RE: AFC Supplement B: Process Water Supply
San Francisco Electric Reliability Project (04-AFC-1)

San Francisco Electric Reliability Project (SFERP) (04-AFC-1)

Supplement B: Process Water Supply

January 11, 2006

Figure 1 Proposed Water Supply Route

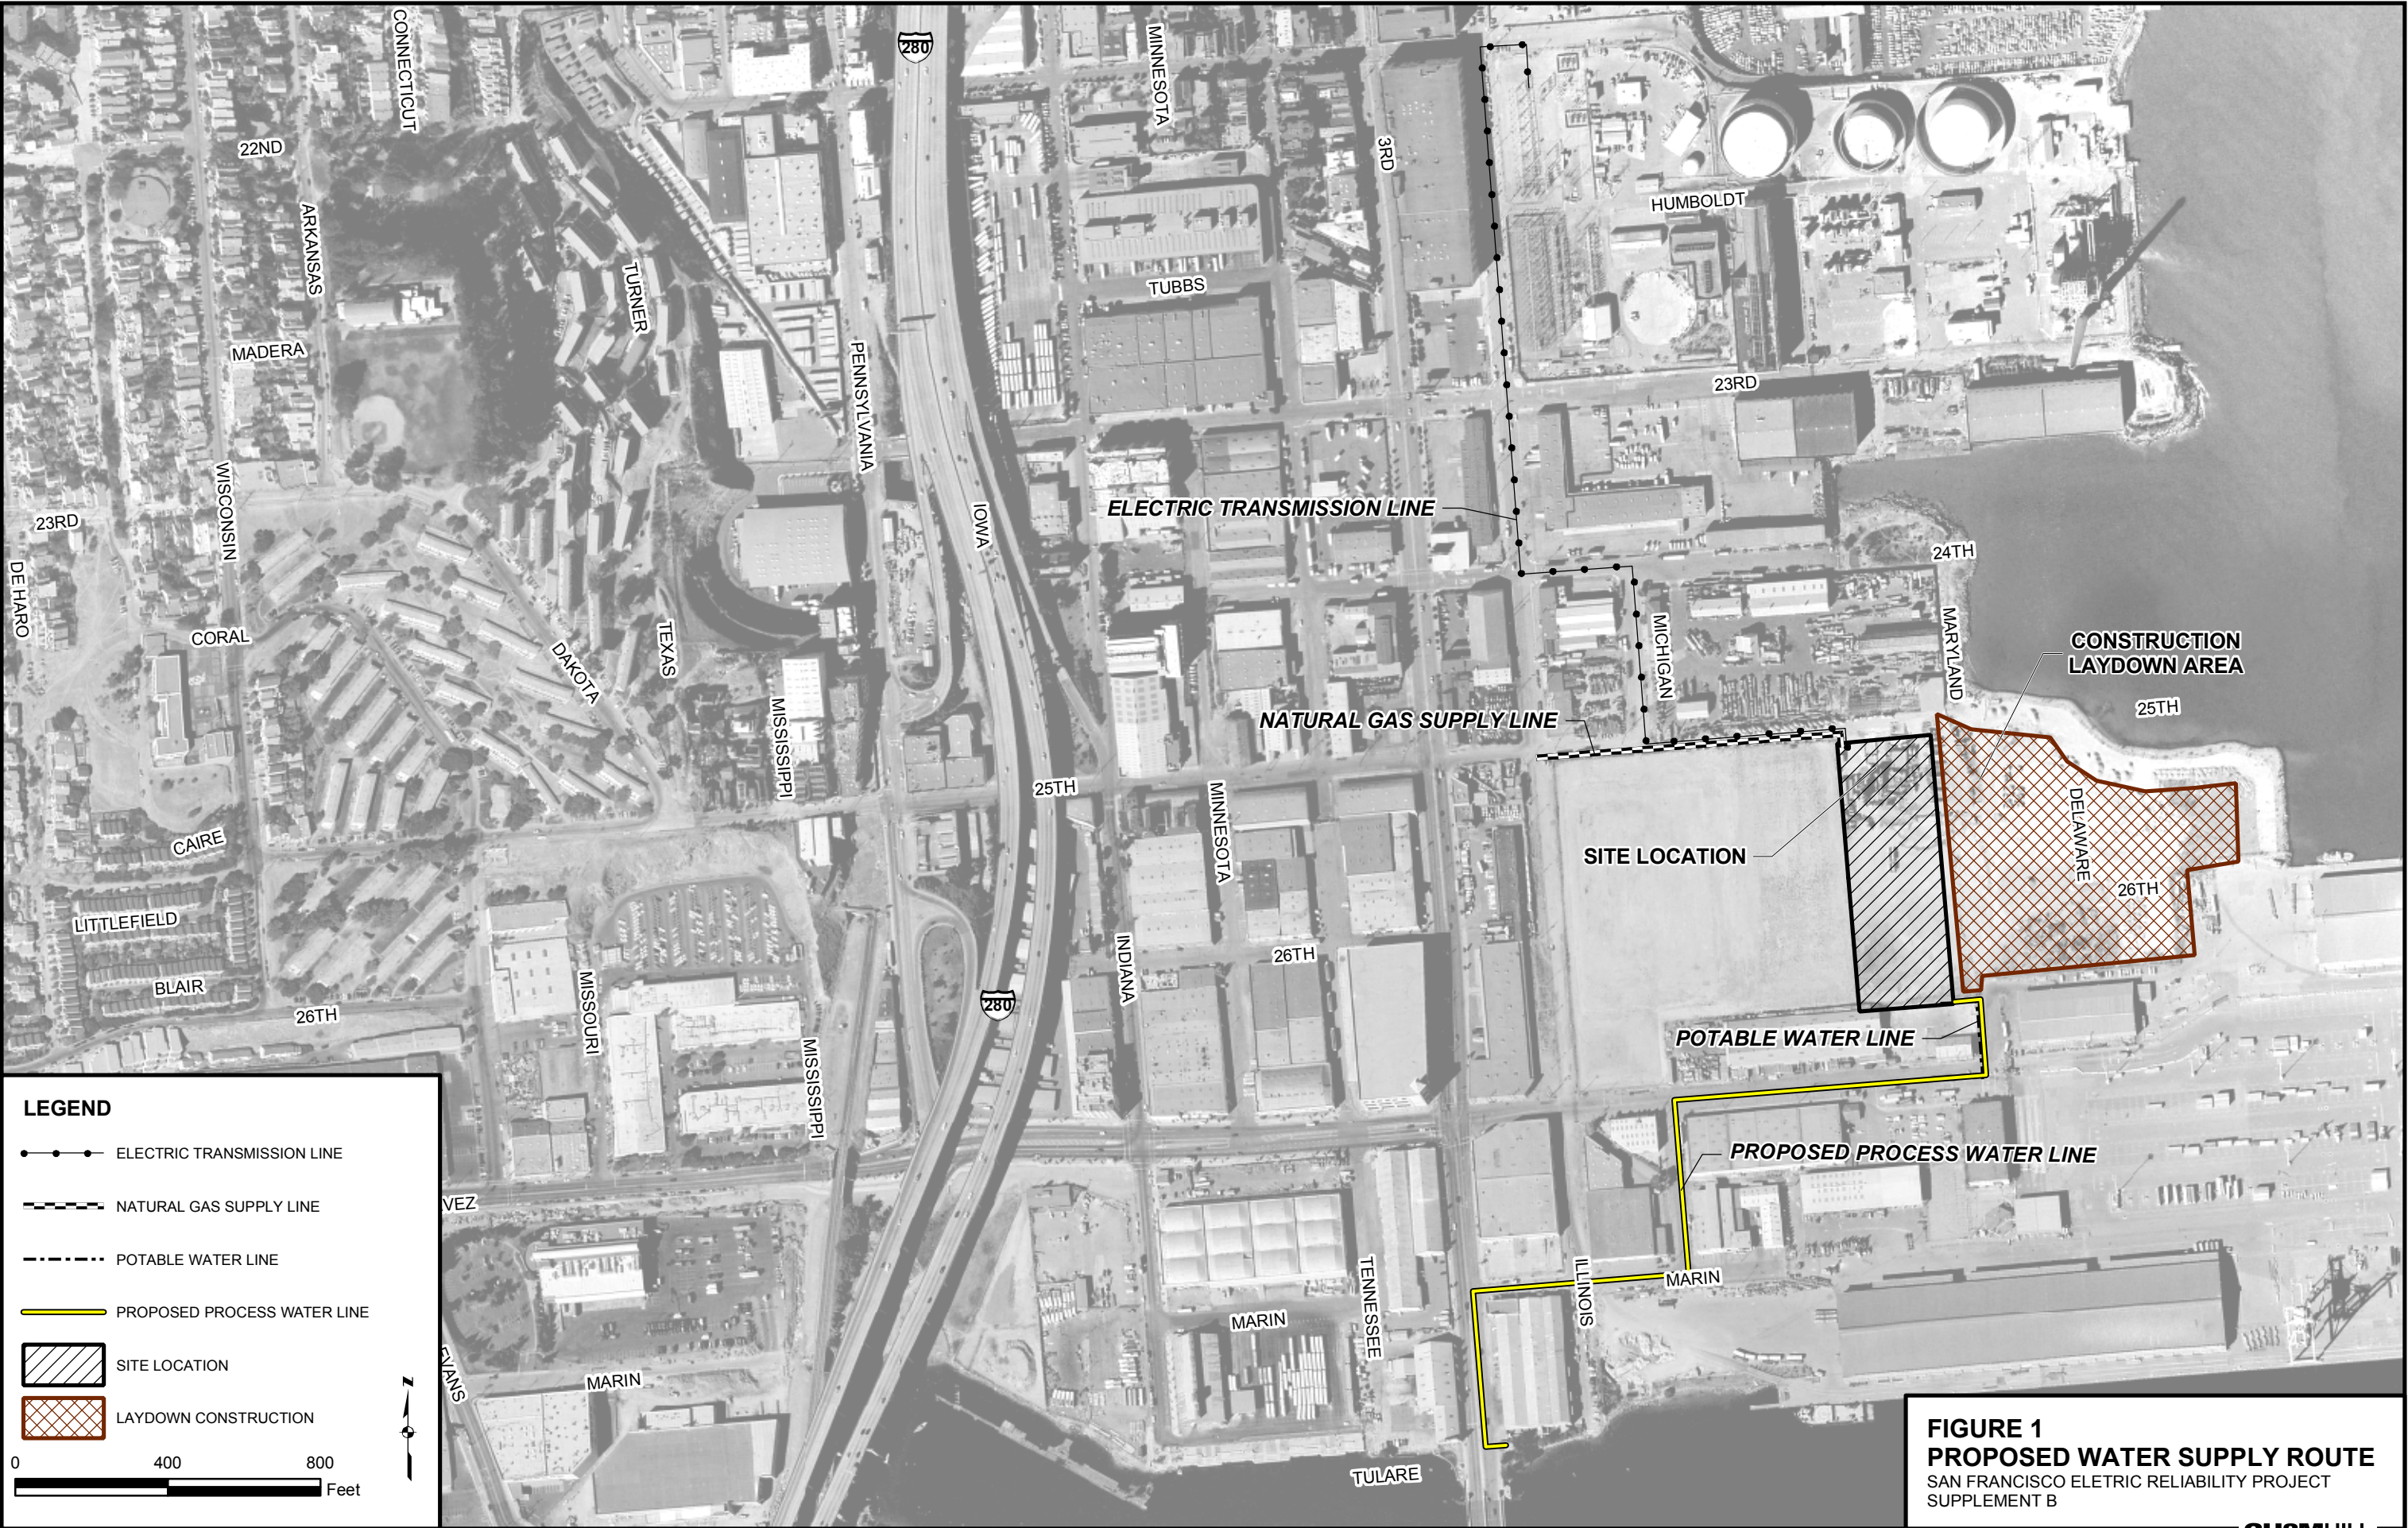
As shown on the attached Figure 1 (figures at the end of the document), the SFERP is proposing to access treated secondary effluent from a pressurized manhole (manhole #2) in the Southeast Waste Water Treatment Plant (SEWWTP) outfall located approximately 2,600 feet from the SFERP. At this location, the water supply is of significantly better quality than the raw wastewater supply from the previously proposed collection box on Marin Street. The improvement in water quality eliminates the need for the traveling band screen and the onsite secondary treatment system using an aerobic tank, reducing the project cost and long-term maintenance requirements. Onsite water treatment will now be limited to tertiary treatment as follows: incoming secondary effluent water supply will go through ultra-filtration followed by disinfection, and then be passed through a single-stage reverse osmosis treatment system. The resultant final water quality will meet full Title 22 tertiary recycled water requirements. The revised process will not require any changes to the chemical inventory for the SFERP (Appendix C in the Hazardous Materials section of the PSA) except that sodium aluminate, a coagulant for plant makeup water, will no longer be used at the site.

The slightly revised process water supply line route will be as follows. An 8- to 10-inch pipeline will leave the plant site and head east about 70 feet to where it will turn south on Maryland Street. It will go about 200 feet south on Maryland Street and turn west on Cesar Chavez Street. It will travel about 850 feet west along Cesar Chavez Street to Michigan Street where it will turn south for 450 feet to Marin Street. At Marin, it will head west about 550 feet to Third Street. The line will go south on Third Street about 400 feet to Tulare Street where it will go 80 feet to the east to connect to manhole #2. No additional equipment will need to be installed at the manhole to pump the water to the plant site. The total length of the line will be about 2,600 feet. That portion of the route along Marin and Third streets will be located above an abandoned 54-inch outfall pipe from the SEWWTP that was replaced by a new 60-inch outfall line at the edge of Islais Creek that parallels the abandoned line. The decision whether to jack and bore under the railroad tracks at Illinois and Marin streets will be made during the detailed design phase.

It is expected that the pipeline can be installed in a relatively shallow trench, with a total excavation depth of approximately 7 feet. The width will be approximately 5 feet with allowance for clearance on both sides of the pipe and trench shoring and sheeting. Trench width will depend on the type of soils encountered and slope required by OSHA

regulations. Trench depth will be sufficient to meet the requirements of the codes and agency having jurisdiction. Moreover, the pipeline will be buried to provide a minimum cover of 3 feet. That portion of the line that will follow along the top of the abandoned 54-inch outfall will have at least 3 feet of cover above the process water supply line and 1-foot separation from the abandoned outfall line.

**FIGURE 2
REVISED WATER BALANCE**
SAN FRANCISCO ELECTRIC RELIABILITY PROJECT
SUPPLEMENT B

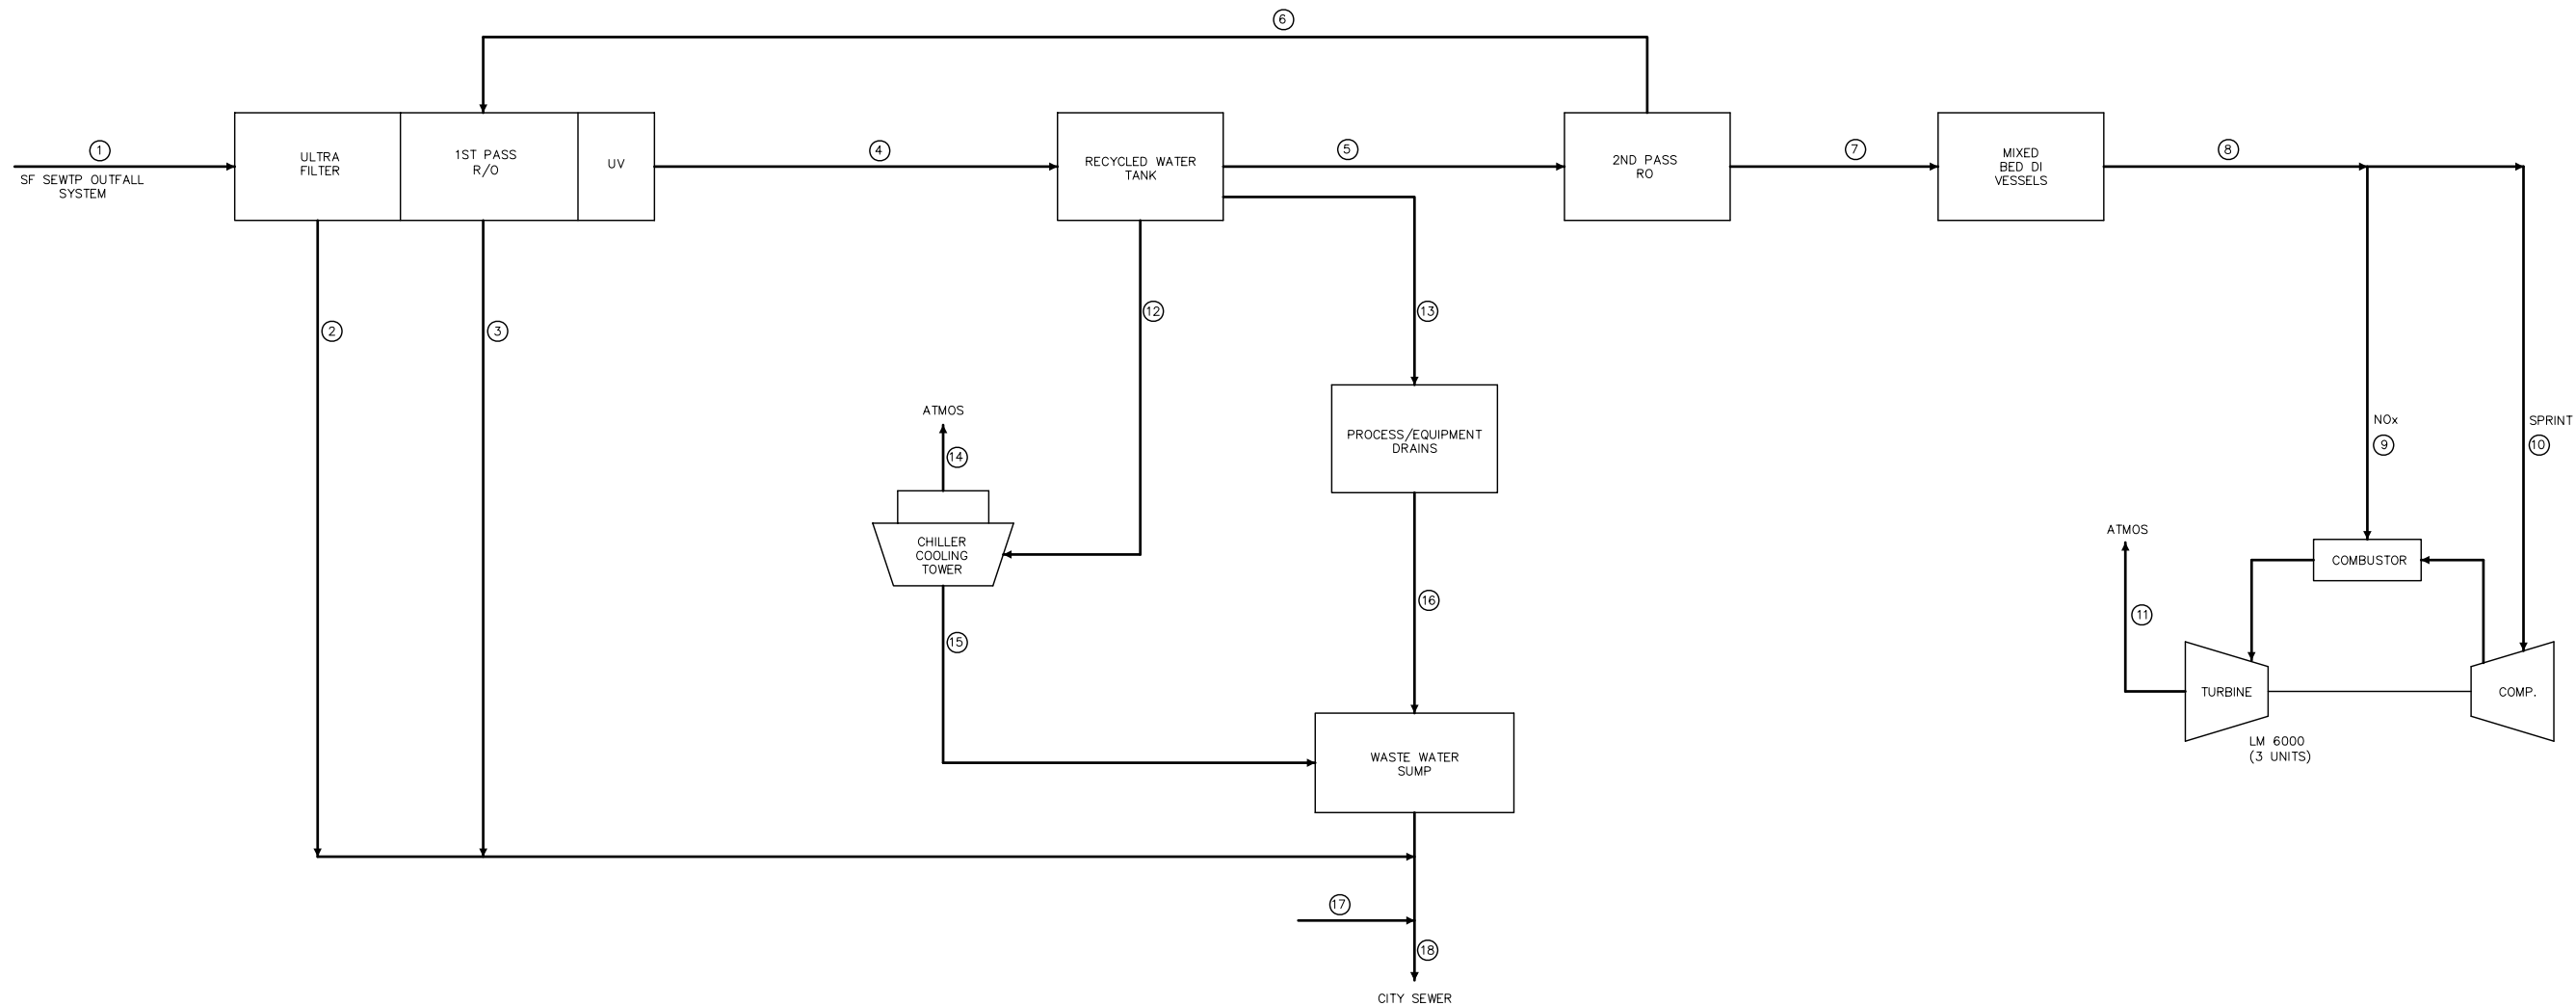
The chemical inventory for the SFERP (Appendix C in the Hazardous Materials section of the PSA) will allow the removal of one water treatment chemical. Sodium aluminate, a coagulant for plant makeup water, will no longer be used at the site. The change in water treatment will not result in any further modifications to the SFERP chemical inventory, will not result in any potential impacts greater than those analyzed in the PSA, and no LORS will change as a result of the revised route. As a result, any potential hazardous materials management impacts associated with this Supplement will be less than significant.

The water supply from the proposed new access point is of significantly better quality than the raw wastewater supply from the previously proposed collection box on Marin Street. The improvement in water quality eliminates the need for the traveling band screen (and resultant discharge of solids back to the sewer system) and the onsite secondary treatment system using an aerobic tank and odor control equipment. The discharge of wastewater after treatment and use will be of the same quality as that previously proposed, but the quantity of water treated and used will change. A revised water balance diagram is included as Figure 2. The proposed modification will not result in potential impacts greater than those analyzed by Staff in the PSA and no LORS will change as a result of the revised
